GE Nuclear Energy

MFN No. 167-93
Docket STN 52-004

Subject: **NRC Requests for Additional Information (RAIs) on the Simplified
Boiling Water Reactor (SBWR) Design**

The reference requested additional information on the SBWR Design. In partial fulfillment of this request, GE is submitting responses to RAIs 950.1 - 950.16 and RAIs 950.21 - 950.26.

ATWS_MSIVC_FMCRD_BASECASE_IC cdr30-SEP-1

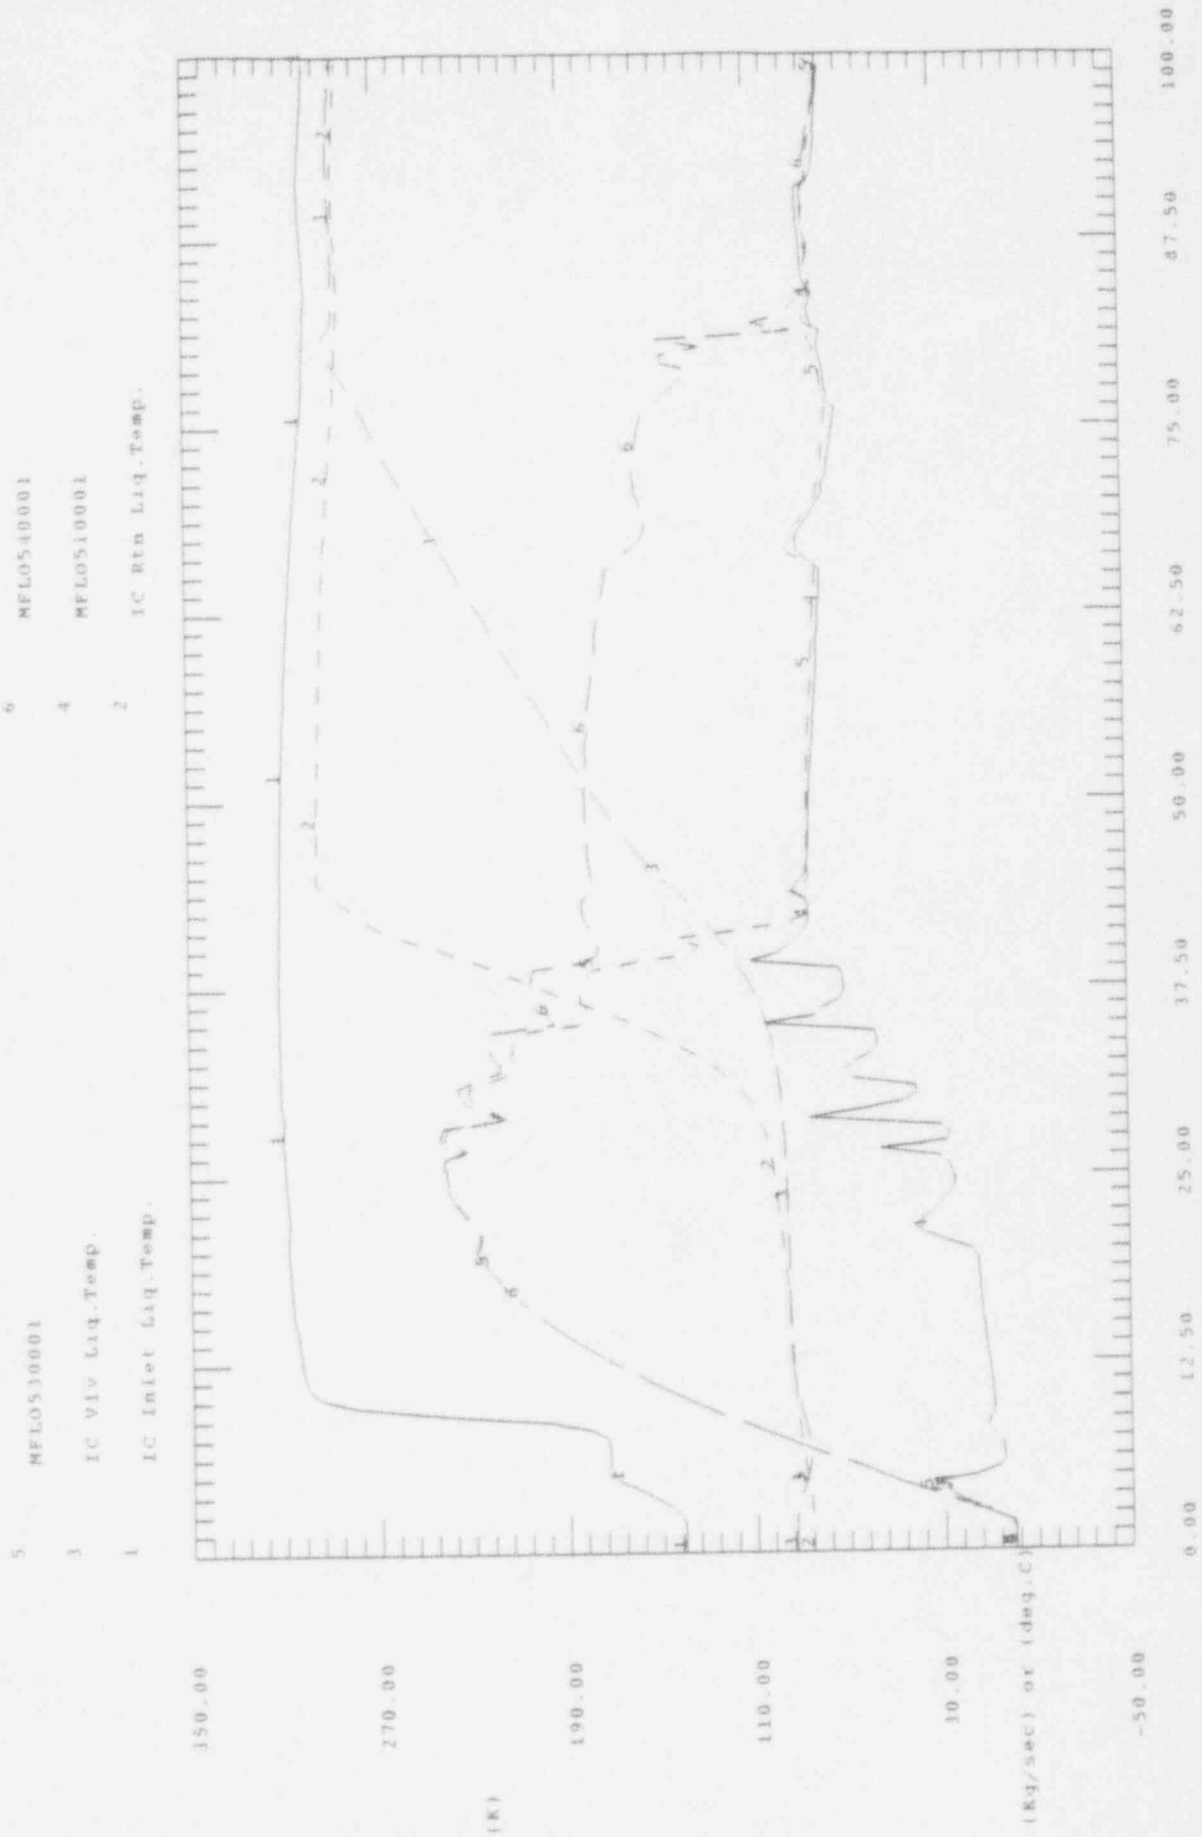
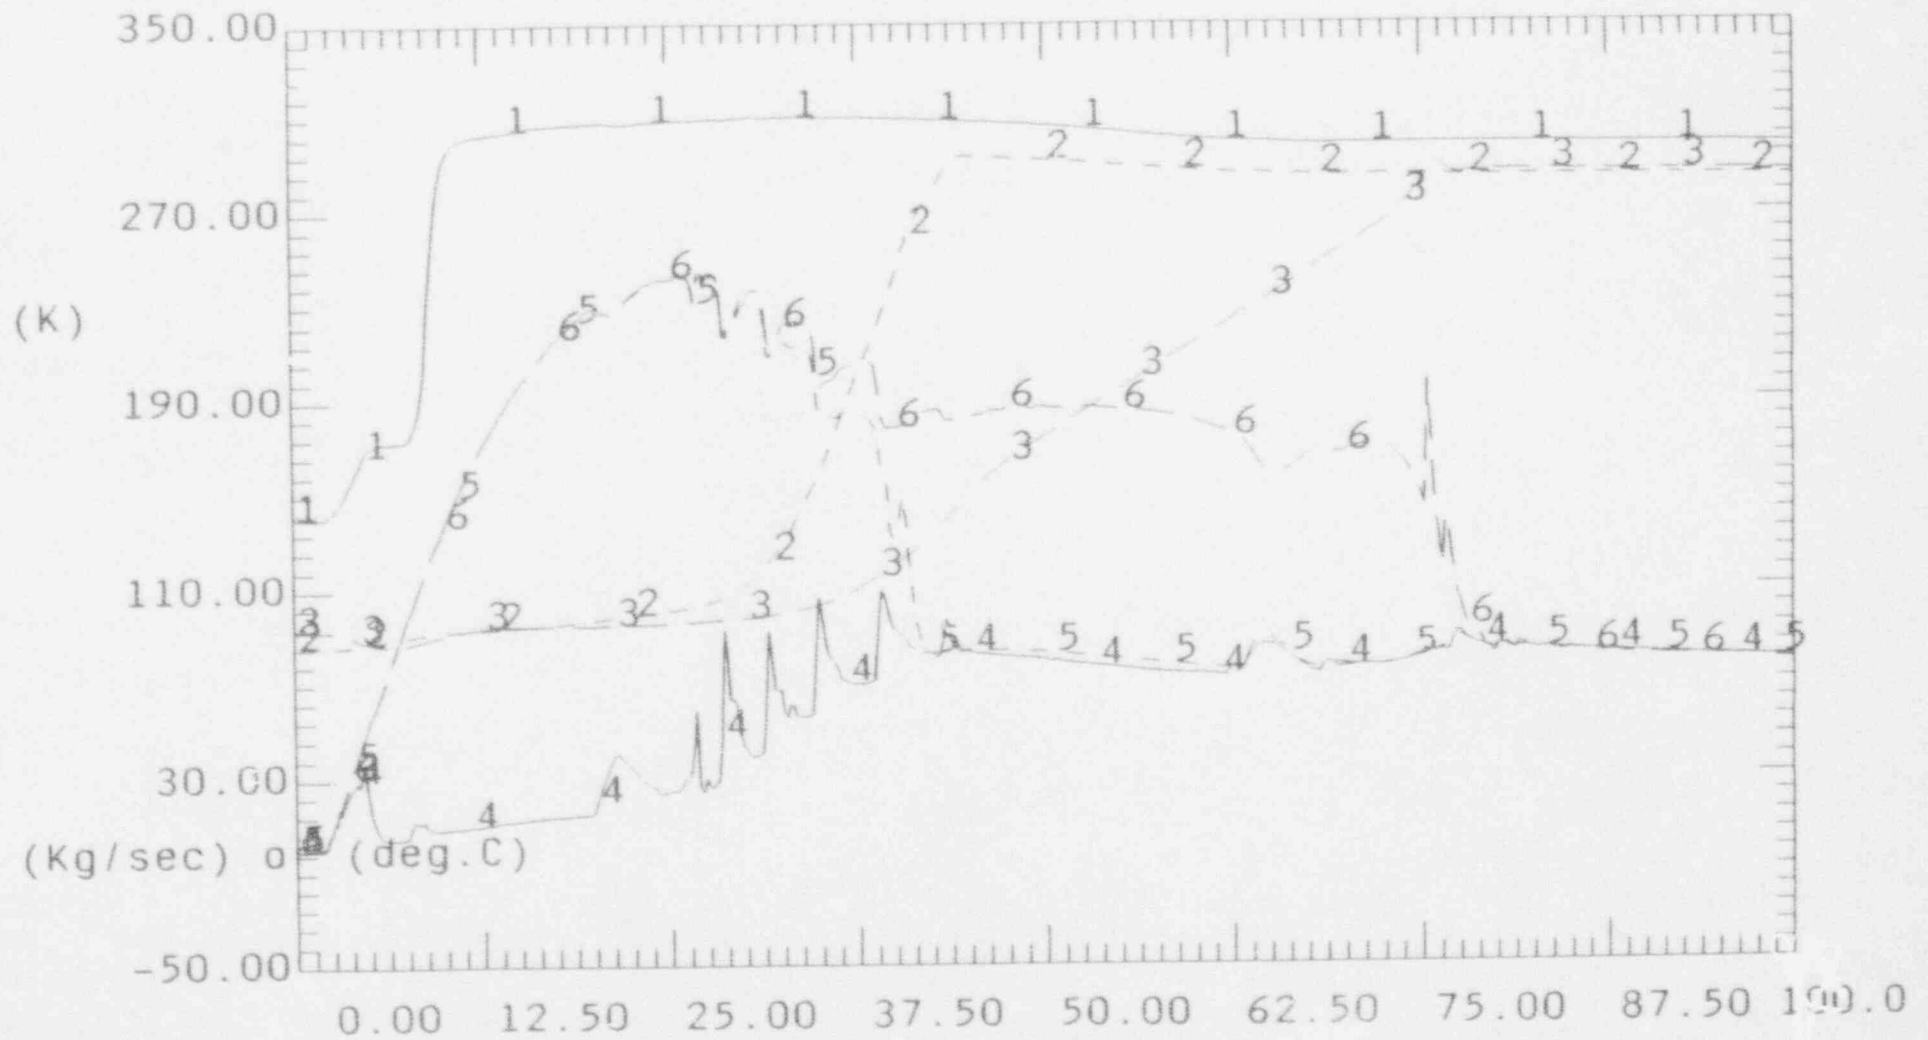
Provide plots of the TRACG predictions for the steam and condensate flow rate from the isolation condensers during the main steam isolation valve closure anticipated transient without scram with fine motion control rod drive (reference SBWR SSAR Figures 15.8-2 and 15.8-3).

The attached 3 figures show the performance of the IC system during the Main Stream Isolation Valve Closure Anticipated Transient Without Scram (MSIVC ATWS). The figures referenced in the RAI are the case with Fine Motion Control Rod (FMCRD) run-in, and Standby Liquid Control System (SLCS) boron injection, data is provided for both cases. A long term and short term plot is provided for the SLCS case. The plots show the draining transient of the Isolation Condenser (IC). The flowrates all initially increase as the drain valve opens. The mass flow in the upper manifold decreases first, when the the short length of supply line with is initially filled with condensate drains, and the flow changes to steam. Later, when the tube bundle has drained, and steam flow and condensate flow begins, its flow drops off. Later still, the lower manifold drains and it's mass flowrate drops. In the long term the system equilibrates in steady state operation, and the 3 flowrates are equal. The figures also show the fluid temperatures and reflect the change from intially cold condensate to saturated steam or liquid. Note that the IC performance is basically the same between the two cases. The IC initiation during ATWS is similar to the milder transients (load rejection, loss of feedwater and isolation with scram.)The flowrate on the attached figures are encoded:

MFL51001 Mass Flow (kg/sec) into the upper manifold from the supply pipe

MFL53001 Mass Flow into the lower manifold from the tubes.

MFL54001 Mass Flow from the lower manifold into the return line.
